Delegated officer report for planning application

Application no. 131616/FO/2021

Proposal: Erection of a first floor rear extension, hip to gable extension, installation of two dormers to Barlow Moor Road and installation of rear roof dormer in association with the use of the ground floor as 2 no. retail units (Use Class E (a); office use on the first floor (use class E (g,i); and formation of 2 no. residential flats (Class C3) in the roof space

Address: 296-298 Barlow Moor Road And 651 Mauldeth Road West, Manchester, M21 8HA

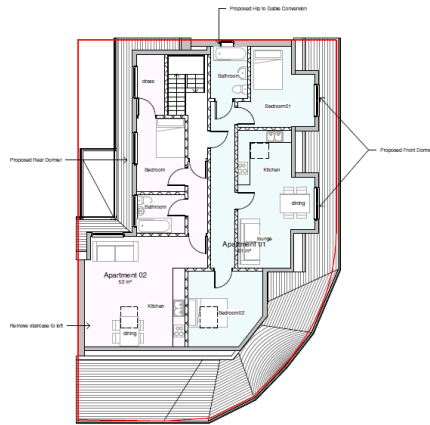
There are no design issues with the proposed hip to gable conversion. Originally it was proposed to install three dormers with dual pitch roofs on the Barlow Moor road frontage. These were over large and appeared incongruous further the dormers did not relate to the windows on the floor below. The dormers have been reduced in number to two, and now relate to the windows on the floor below. The use of a shed style also reduces the massing and bulk of the dormers.

It is considered that the revised dormers are acceptable.

The rear dormer is much simpler in design but is generally considered acceptable for this elevation.

The proposed extension is tucked away to the rear it is built over the yard but its small size and flat roof ensure it is not intrusive. The design of the extension is considered acceptable.
